Service Bulletin: SB 407-3010; Bell Helicopter Model 407 Air Conditioner

Compressor Belt Tensioning Collar replacement

Removal & Replacement of the Compressor Belt Tensioning Collar.

30 August, 2004, Rev N/C

Figure 1-1 Installation of Compressor Drive Pulley and Drive Ring Assembly

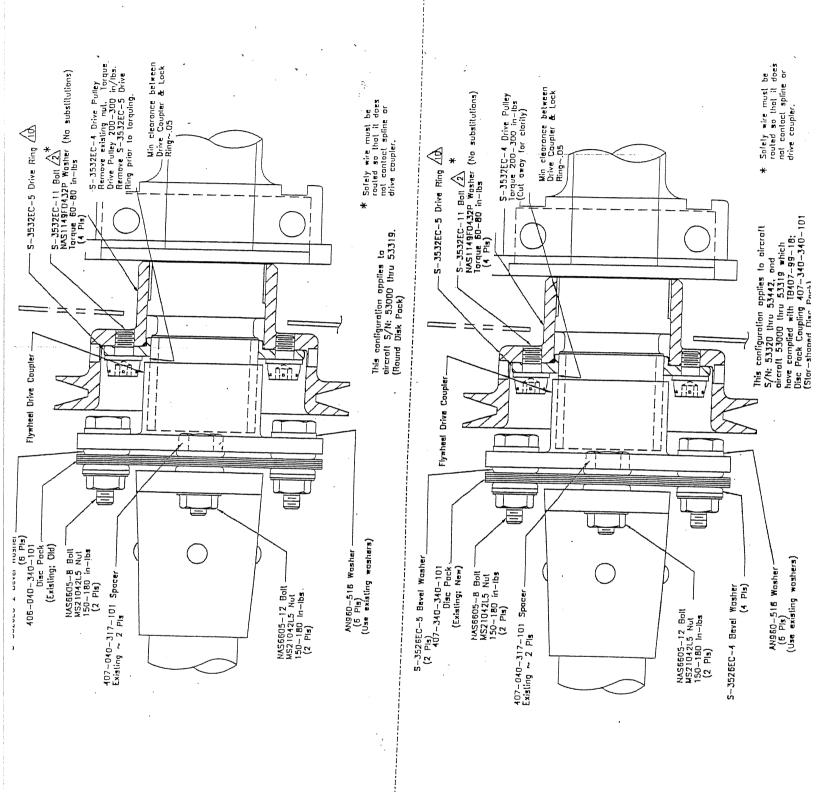
B. Remove the four Bolts from the tailrotor driveshaft coupling forward of the compressor drive pulley installation. (See Figure 1-1)

- F. Re-connect the Tailrotor drive shaft retaining bolts, nuts and washers. Torque nuts to 150 180 in lbs. (See figure 1-1)
- G. Reinstall the Compressor drive belt and tension belt using the Belt Tensioning Link. Tension belt to 52 in lbs. A properly tensioned drive belt will have a 0.1" deflection when 3 lbs of force is applied to the mid span of the belt.

- B. Torque the S-3532EC-4 Compressor Drive Pulley to 200 300 in lbs (22.59 33.89 Nm), using a .257 Dia X .13 Deep Spanner Wrench, utilizing one of the (4) four available holes on the pulley body.
- C. Install new Drive Ring S-3532EC-5 on to the Driveshaft Spline, and slide into place aligning four (4) of the twelve holes provided in the Drive Ring with four (4) of the twelve (12) threaded holes located in the Compressor Drive Pulley. (See note 10).

D. Once the correct hole alignment is accomplished between the Drive Ring and the Compressor Drive Pulley. Install the four (4) S-3532EC-11 Bolts and AN960-PD416 Washers and torque to 60 – 80 in lbs. (6.77 – 9.03 Nm) and safety bolts using .032 safety wire (See note 2).

E. Reinstall Driveshaft coupler, (Flywheel if applicable), and existing Drive Shaft mounting Bolts, torquing the MS21042L5 Nuts to 150 – 180 in lbs. (16.94 –20.33 Nm).

Figure 1-2 Installation of Compressor Collar Installation view looking Down.

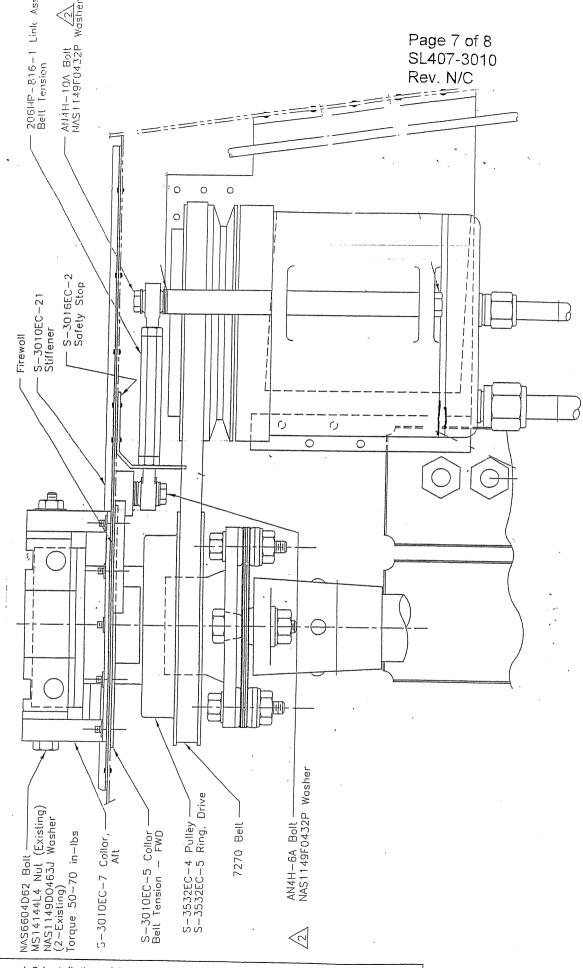
Field reports have indicated that cracks in the welds attaching the S-3010EC-13 Block to the S-3010EC-24 Plate have occurred on some S-3010EC-5 Collar Assemblies. These parts have been identified as having come form a particular lot of parts which were shipped in kits between 10/08/03 to 07/12/04.

To replace the existing air conditioner Compressor Belt Tensioning Collar, P/N S-3010EC-5 Rev L, with P/N S-3010EC-5 Rev M, for the above listed Kit Numbers.

- 2. Removal / Installation of Compressor Belt Tensioning Collar.
 - A. Cut the safety wire and remove the AN4H-6A Bolt from the top half of the Belt Tensioning link.
 - B. Remove all eight (8) of the MS24693-S-272 Screws from the S-3010EC-5 Belt Tensioning Collar and remove the Collar from the aircraft.

It will be necessary to match drill and counter sink four of the holes in the new S-3010EC-5 Collar, and Pro-seal per Note 12.

- C. Install new S-3010EC-5 Belt Tensioning Collar In reverse order of its removal.
- D. Reinstall the AN4H-6A Bolt in the top half of the Belt Tensioning link, safety wire bolt using MS20995C-32 Safety Wire per MIL-P-8564 Paragraph 3.3.7.
- 3. Installation / Replacement of the Compressor Pulley and Drive Ring.
- A. Install the new Compressor Drive Pulley S-3532EC-4 on the Tail Rotor Driveshaft, threading the pulley tightly against the face of the Driveshaft Hanger Bearing Retainer.
